Subject: RE: Belle Terre Multi-use Path Ph3

During my site visit yesterday and in response to your statement below that Cline has been busy repairing the washouts and the silt fences, the following areas were noted that have not had the silt fence repaired as you claim and still require immediate attention:

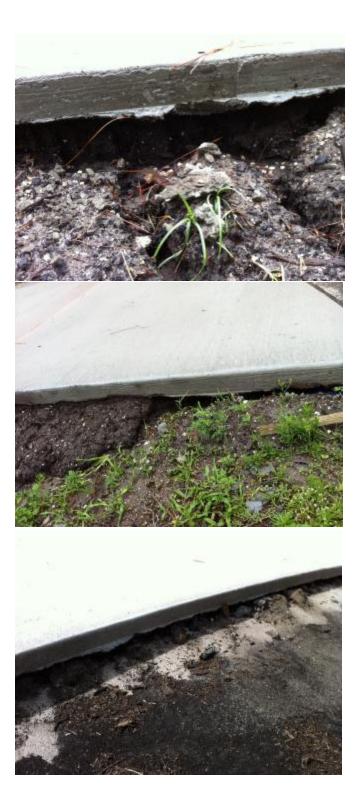
Attached below are photos of the typical washouts that have been occurring along this Belle Terre project. The plan details on Sheet G-4 shows a 6" compact subgrade to 95% extending 1' beyond both sides of the width of the concrete pathway. This is the detail that was approved by FDOT. CPH as the EOR needs to provide direction as how to correct erosion areas and obtain compaction as well as testing requirements to comply with FDOT specifications.

These photos were taken Wednesday afternoon, 8-8-12, prior to the rain event.

Cline's response to our request for them to remove the form boards, backfill to elevation, re-compact, and re-test for density, is listed below.

Item #6 Areas eroded around form boards will be filled and compacted. The form board removal is not required. Densities have passed in this area. If the City wants to verify the density of a 2" deep wash out then that is up to you.
